## Report to the Plan Commission

December 17, 2012

**Legistar I.D. #28589**  
**1127 North Sherman Avenue**  
**Conditional Use Request**

Report Prepared By:  
Heather Stouder  
Planning Division Staff

Figure I-10: Conceptual Designs for the Northgate - Kraft/Oscar Mayer Area.

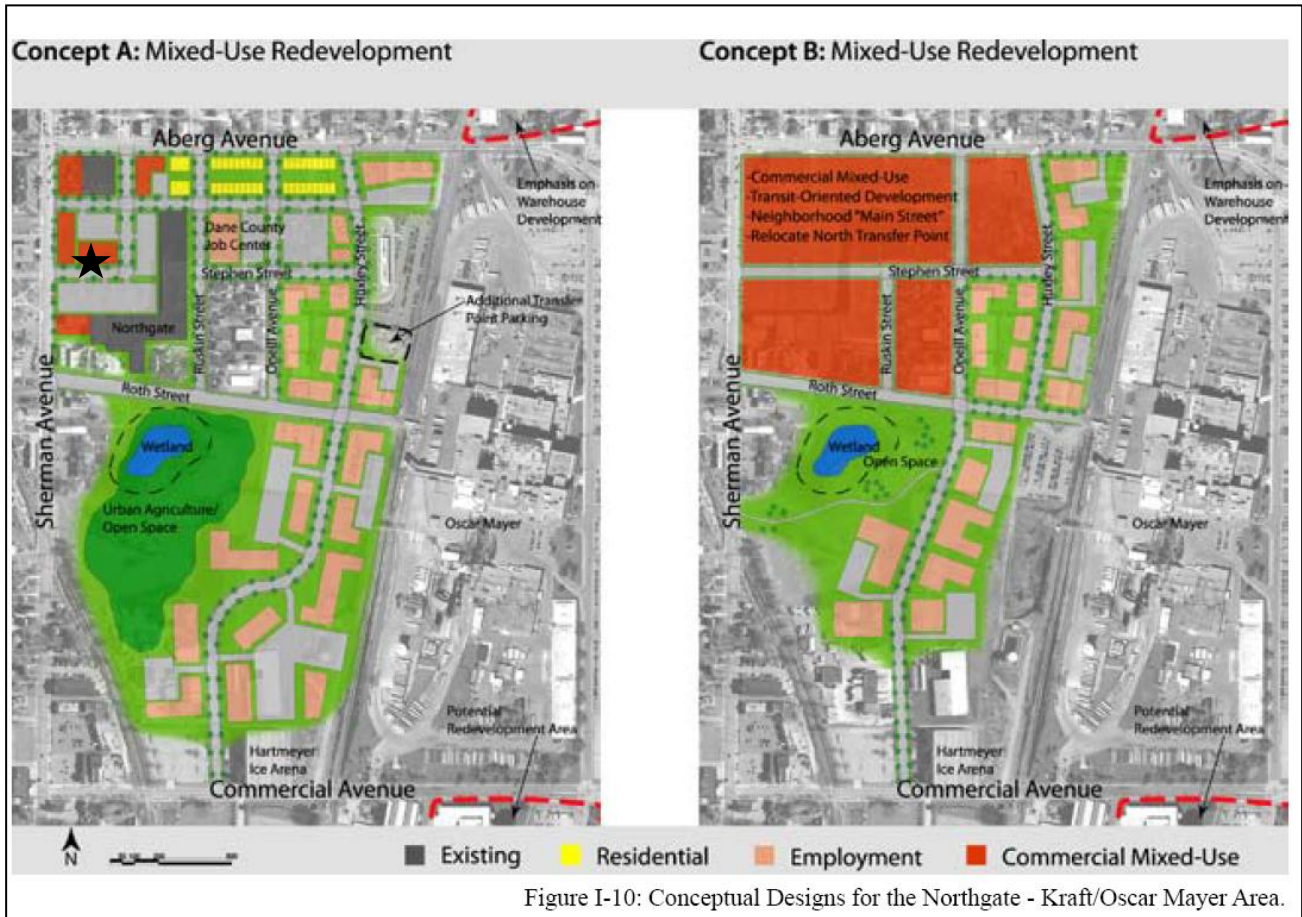
Further, the addition of this building would not preclude opportunities for significant redevelopment of this area as recommended in the Northport-Warner Park-Sherman Neighborhood Plan. Actually, its placement adjacent to a driveway entrance to the shopping center is generally consistent with one of the conceptual designs for mixed-use redevelopment provided in the plan (see Concept A below).
